PLANNING COMMISSION MEETING STAFF REPORT

NAME OF PROJECT: Cozens Subdivision

AGENDA ITEM: Preliminary/Final Approval

Subject: Cozens Subdivision, – Preliminary / Final Approval

COZENS SUBDIVISION PLAT - 8 APRIL 2019

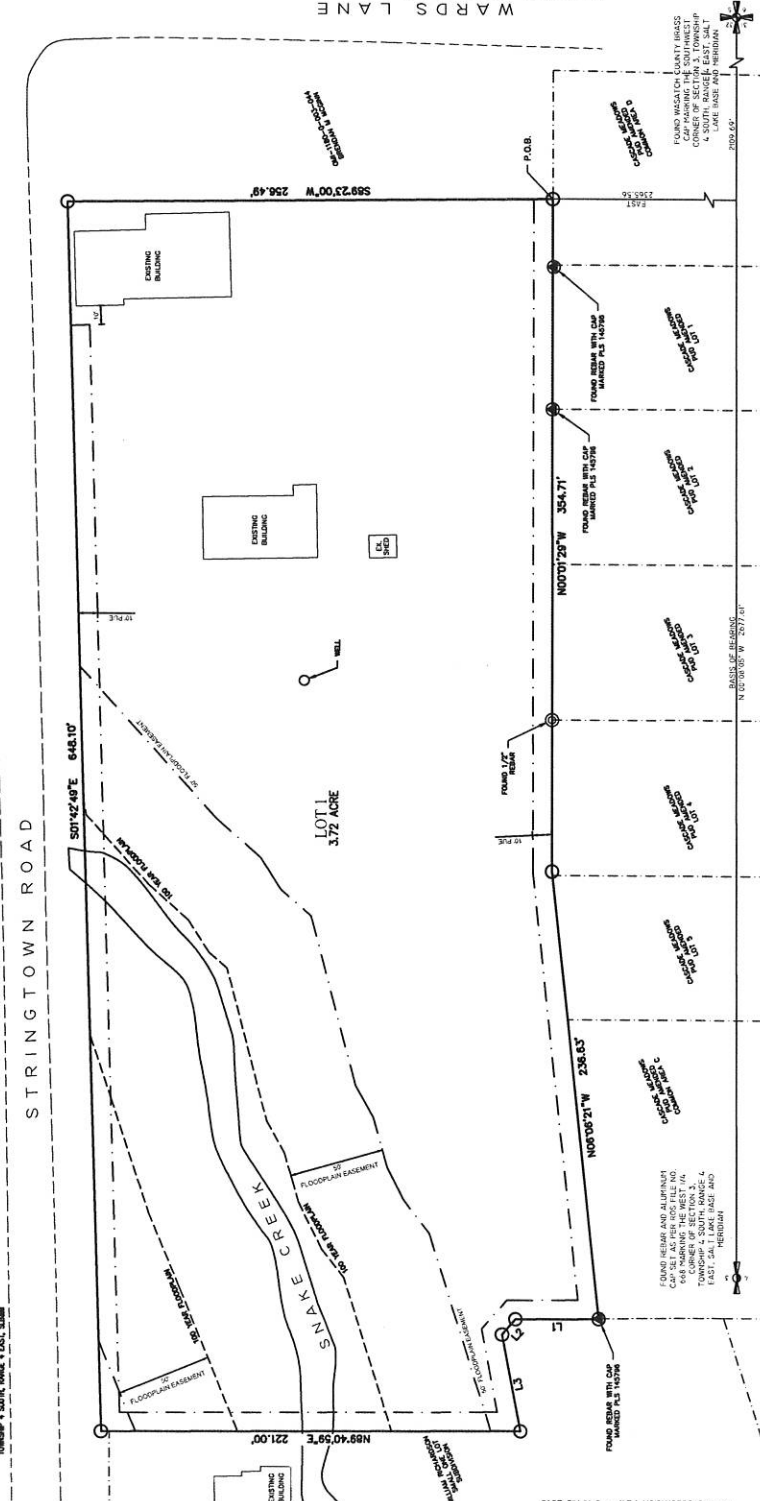
There are sensitive lands present on the property. Snake Creek runs through the northeast section of the property. A FEMA floodplain accompanies Snake Creek which requires a 100' setback or any structures. The submitted plans do show the floodplain with the required 100' setback.

Sensitive lands – Snake Creek runs through the property and has a FEMA floodplain associated with it. A 100' setback is required for all structures from the FEMA floodplain which will be shown on the plat limiting where future structures may be located.

Setbacks – A 50’ setback is required for any structures built in the proposal. The required setback will be noted on the plat.

- The small scale subdivision is not proposing to construct any new roads or public infrastructure. If the plat is further subdivided, the existing sewer line at the intersection of Stringtown Road and Wards Lane should be extended to the North boundary of the subdivided plat.

- The existing home is served by the existing 10" water line within Stringtown Road.

- The existing Stringtown Road shoulder will contain the storm water.
